DOCUMENT CHANGE REQUEST

DCR number 124	Changes required for: General	Originator: S Thacker
Date: 2004/06/08	Date sent: 2004/06/08	Organisation: ESA/ESTEC
Status: IMPLEMENTED

Title:	CMOS Quad 3-State NOR R/S Latches, based on type 4043B		
Number:	9202/042	Issue:	1

FIGURE 3(c) - CIRCUIT SCHEMATIC (EACH LATCH)

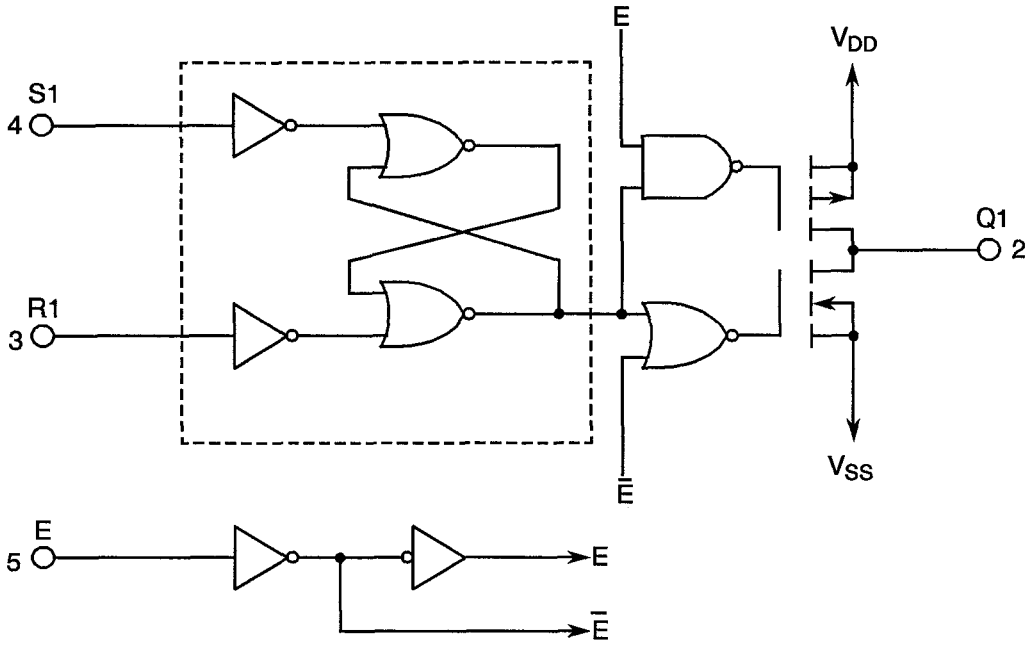
Page 14 Figure 3(c) Circuit Schematic

Original figure was incorrect (it was an equivalent NAND Latch)

Figure is amended to reflect an equivalent NOR Latch (as para 1.8 Functional diagram in amended spec) - see original and amended version as attached.
